APPEAL SUMMARY

Appeal ID: 19045	Project Address: 815 W Burnside
Hearing Date: 2/20/19	Appellant Name: Tom Jaleski
Case No.: B-014	Appellant Phone: 9712385266
Appeal Type: Building	Plans Examiner/Inspector: Steven Mortensen
Project Type: commercial	Stories: 6 Occupancy: R-2, S-2, M, B Construction Type: I-A, III-A
Building/Business Name:	Fire Sprinklers: Yes - throughout
Appeal Involves: Erection of a new structure	LUR or Permit Application No.:
Plan Submitted Option: pdf [File 1] [File 2] [File 3]	Proposed use: Residential, parking, retail

LANDSCAPE - ROOF PLAN

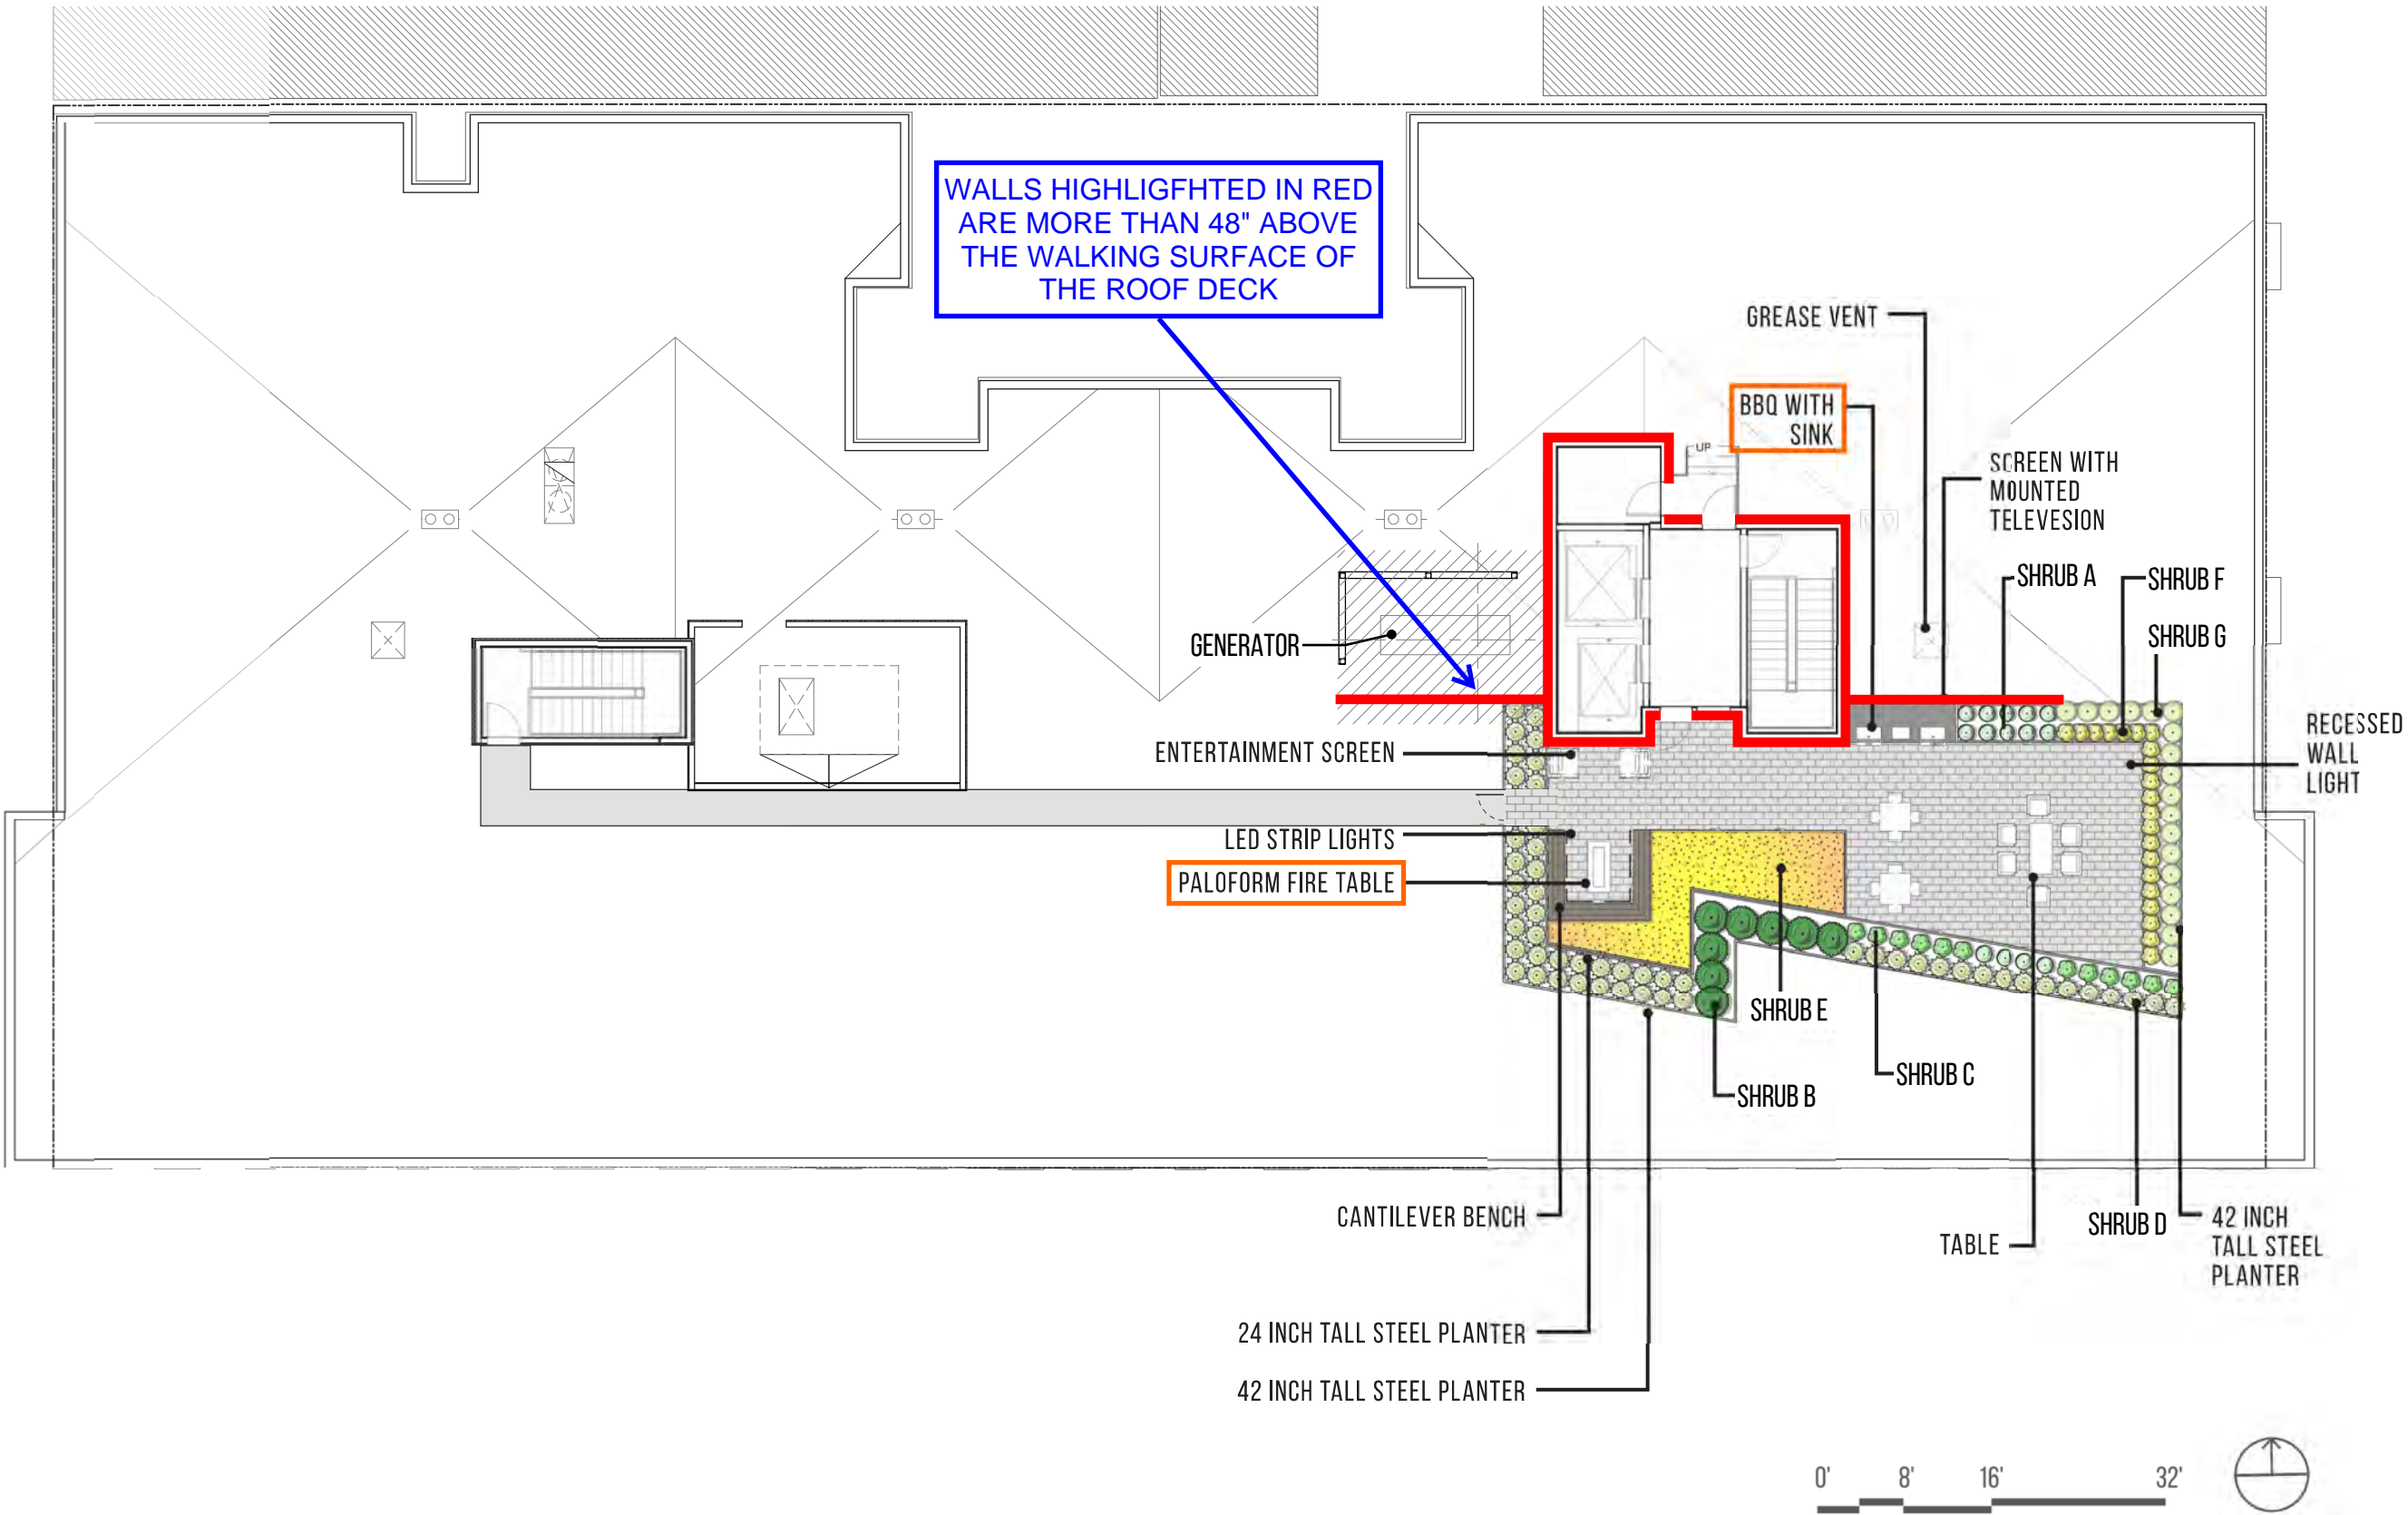
The proposed design is to meet the requirements of 2018 IBC, 503.1.4 and 503.1.4.1, and approved for the 2019 OSSC, except the roof deck has a single wall that exceeds 48". The roof deck has additional walls that exceed 48" but they are penthouses for stairs and elevator and meet the exception of 503.1.4.1.

Walls, except as allowed per 503.1.4.1, exception, will be 72" max above the roof deck level, only along one side of the deck and will not have any horizontal elements.

The roof deck is an unenclosed, defined area. The roof deck is less than 750 square feet in size, and will have less than 49 occupants and considered a B occupancy. Only one wall along one edge of the roof deck will exceed 48", but will not be tall enough to support any structure that might shelter occupants. The single wall that will be no more than 72" tall meets the intent of 503.1.4.1. The 72" wall will be covered in a weather tight material that is non-combustible, will be separated by occupant areas by a counter, and will not have any horizontal elements. There will be a small horizontal element on the penthouse that provides weather protection only at the door. The wall will not be high enough to support any future horizontal structure inhibit egress or fire fighter access to the roof as it is only on a small portion of the roof and a second stair penthouse is provided beyond the end of the 72" tall wall. There is a door directly from the elevator/stair lobby to the deck side and to the roof side to ensure fire fighter access to the roof is provided from a protected environment without accessing the roof deck area.

The building has a roof deck that meets all the requirements of 2018 IBC and 2019 OSSC 503.1.4 and 503.1.4.1 except one wall exceeds 48" on one side. The wall meets the intent of 503.1.4.1 by being no more than 72" tall, not capable of providing a horizontal element in the deck area, does not hinder egress or fire fighter access to all parts of the roof and request approval of the appeal.

1. Roof deck located above maximum number of stories: Granted as proposed per ICC approved 2018 IBC model code change lifting restriction on location of roof decks in a fully sprinkled building and with occupant notification in the area of the occupied roof. Elements or structures enclosing the occupied roof areas shall not extend more than 48" inches above the surface of the occupied roof (except as identified within this appeal). Fire Marshal's office may revoke if found to be in violation of this appeal.

WALL SECTION AT WINDOWS FACING PROPERTY LINE

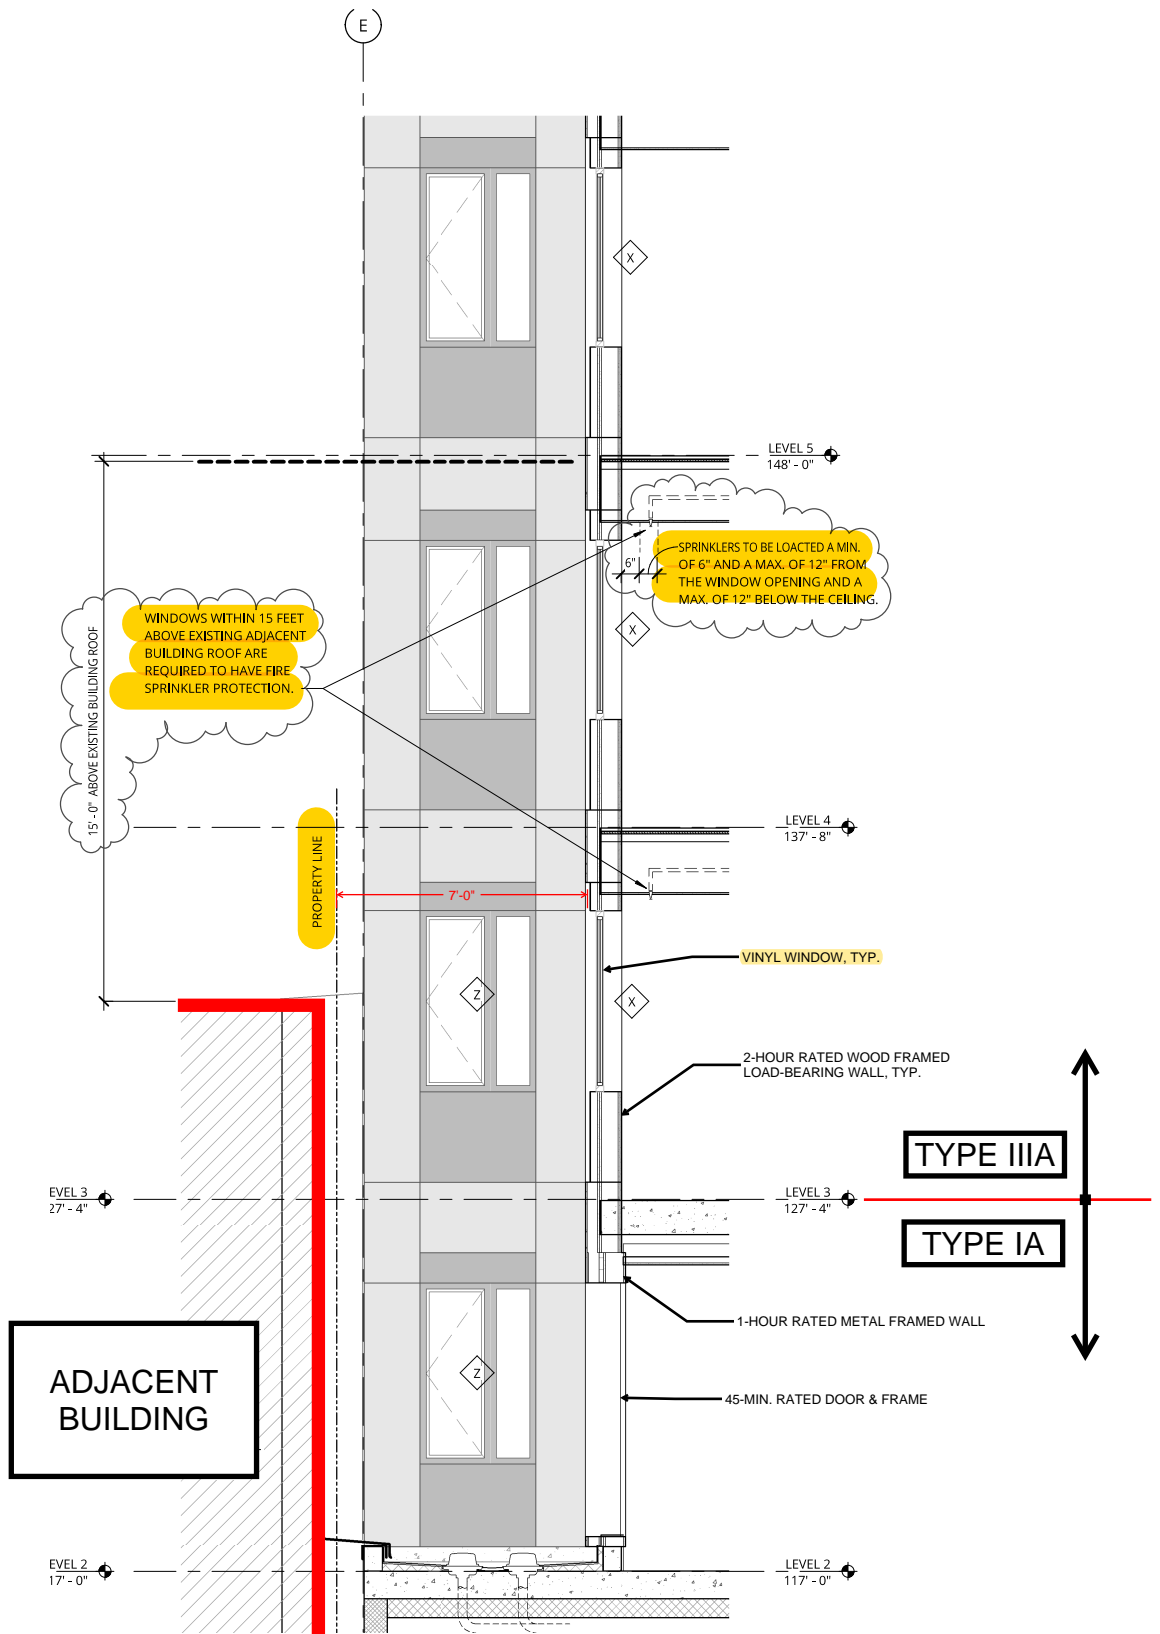
At each of levels 3 – 7, there is one 2'-0" wide non-operable window located at the end of a 5'-2" wide corridor. Each of the five windows are within 15 feet horizontally of the adjacent structure, and two of the five windows are within 15 feet vertically above the adjacent structure's roof. These two windows are located at level 3 and level 4. OSSC 705.8.6.2 requires these two windows to be 3/4-hour rated. The proposal is for these two non-operable windows to be non-rated with a fire

sprinkler head above each window opening. Providing an adjacent fire sprinkler on the inside of the building at each of these windows will provide equivalent protection to the required 3/4-hour rating. There are no proposed mechanical openings in the wall.

We believe that having small window openings, having non-operable windows, and providing adjacent fire sprinkler heads to protect the window openings will provide equivalent fire protection as 3/4-hour fire rated windows.

2. Type 13 water curtain sprinkler protection at non-fire rated openings in buildings with vertical exposure on separate lots: Granted provided windows are non-operable and sprinklers are spaced not more than 6 feet apart and placed a minimum of 6 inches and a maximum of 12 inches from the opening (s) and a maximum of 12 inches below the ceiling. Sprinklers are to be installed on the occupied side of the openings. A separate permit from the Fire Marshal's Office is required.

Note: This decision doesn't grant any mechanical openings.
